From: Sara Roediger, AICP
Date: 1/6/2016
Re: **Brampton Parc PUD (City File #15-001)**
PUD Final Plan - Planning Review #2

From: Jason Boughton, AC *P.G.S. FOR*
To: Sara Roediger, Manager of Planning
Date: December 29, 2015
Re: Brampton Parc, City File #15-001, Section 24
Final PUD Review #2

From: Craig McEwen, R.A., Building Inspector/Plan Reviewer *CPN*
To: S. Roediger, Planning Department
Date: November 24, 2015
Re: Brampton Parc – Review #3
Sidwell: 15-24-301-052
City File: 15-001

Sara Roediger
Department of Planning and
Economic Development
City of Rochester Hills
1000 Rochester Hills Drive
Rochester Hills, MI 48309-3033**Subject: File No. 15-001 Brampton Parc PUD;
Wetland Use Permit Review #5;
Plans received by the City of Rochester Hills on
December 22, 2015****Applicant: 1459 John R LLC**

CITY OF ROCHESTER HILLS
STANDARD DETAIL FOR:
Sight Distance
Roadways

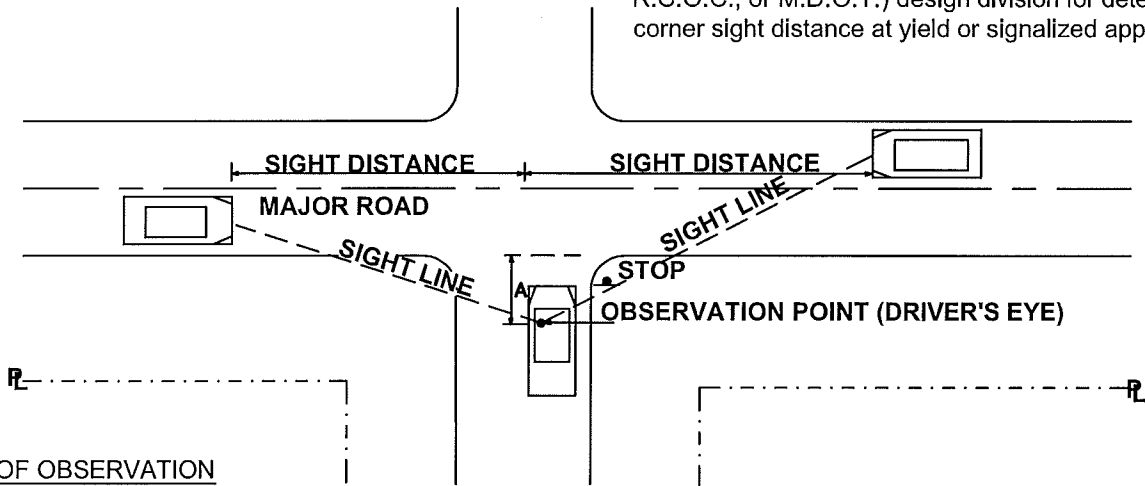
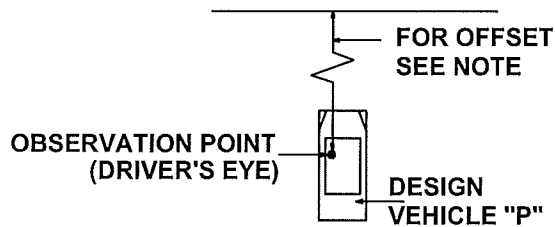
1. The pathway and roadway sight distance lines are technically shown incorrectly on the landscape plan. The pathway site line should extend 150 feet in each direction from the vehicle reference point 18 feet off path edge, as shown on plans, to the center of the path. 150 feet is used at this time since we don't have detailed proposed grades. A second sight line for the road sight distance should be shown from a point 18 feet off the edge of the travel lane at a distance of 500 feet in each direction. City detail is attached. This revision will not impact the proposed plantings as shown on landscape plans.
2. The existing utility pole locations near the right turn lane and taper will need further evaluation during construction plan review to determine if they need to be relocated outside of the clear zone.
